<b>TaunTek</b>		
<b>Matrix 6 LCD Display</b>		
R. Grieb	Rev 1.1	Page 1 of 1
	1/23/2015

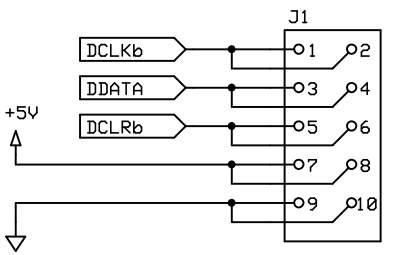
For LCD modules needing  
 current-limiting resistor  
 for backlight, R3-6 will need  
 to dissipate significant power

Probably this type of backlight  
 would draw too much current for  
 M6 supply anyway.

RA4 is open drain  
 RA5 is input only
